Phase II Bond Release, Western States Minerals, J.B. King Mine, ACT/015/002-99B,

File #2, Emery County, Utah

On June 11, 1999, the Division received a Phase II and Phase III bond release request from Western States Minerals. The Division's response on July 6, 1999, states the amendment will be processed for Phase II bond release only. This review covers soils related issues concerning soil stabilization and acid/toxic forming materials. This review concludes that the Phase II bond release submittal is incomplete.

Figure 1. Area 3 gully erosion into coal refuse material.

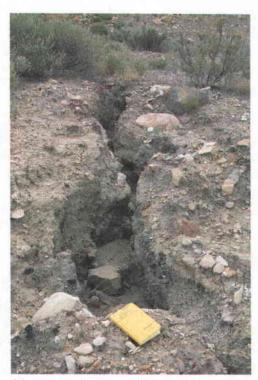
Reclamation at the J. B. King Mine was conducted in 1985-86. The resulting convex surface results in a land form predisposed to erosion. Currently no refuse is exposed at the refuse pile. However, it is obvious that rills and gullies have formed at the reclaimed site, especially in the area located south of the refuse pile and north of the main drainage channels. In this east-central site area, off-site drainage flowing across the reclaimed surface has resulted in considerable rill and gully formation, often exposing buried coal refuse material (Figures 1 thru 3); this exposed coal refuse is not associated with the refuse pile. Refuse is also exposed at the lower end, north east eroding bank of the main, right fork drainage channel (Figure 4). This east-central site area is identified as AREA 3, Figure 2, JB King Mine site Layout Transect and Area of Influence Map, Soil Loss Evaluation of the Reclaimed JB King Mine, May 1999, WSMC Engineering, Reno, Nevada.

UCA 40-10-17(j), (i), p4(A) specifies that reclamation must prevent or remove water from contact with toxic-producing deposits. As evidenced by the exposed coal refuse materials in the rills, gullies, and channel, water has been in contact with possible toxic-producing deposits. According to the October 5, 1995 incorporated amendment, harmful effects of toxic and acid forming materials should be nullified through the erosion process by mixing with other non-toxic/non-acid forming materials. The sedimentation pond captures the sediment and runoff. Over the life of reclamation, neither the Division nor Western States Minerals has ever observed or recorded any discharge from the sedimentation pond. At a minimum, the pond sediments should be sampled for toxic and acid forming characteristics according to the Division's guidelines for topsoil and overburden. After storm events, the pond water should be sampled according to State criteria for water quality, including selenium and pH. If sampled sediment and water test results prove negative accordingly, then bond release should proceed. If the test results prove positive, additional measures must be considered and implemented prior to bond release.

UCA 40-10-17(j), (i) p4(A), R645-301-120, and R645-301-731.300, Sample and analyze the pond sediments for toxic and acid forming characteristics according to the Division's guidelines for topsoil and overburden. Provide analyses for sediment pond water, at seasonal high and low water levels, according to State criteria for water quality, including selenium and pH.
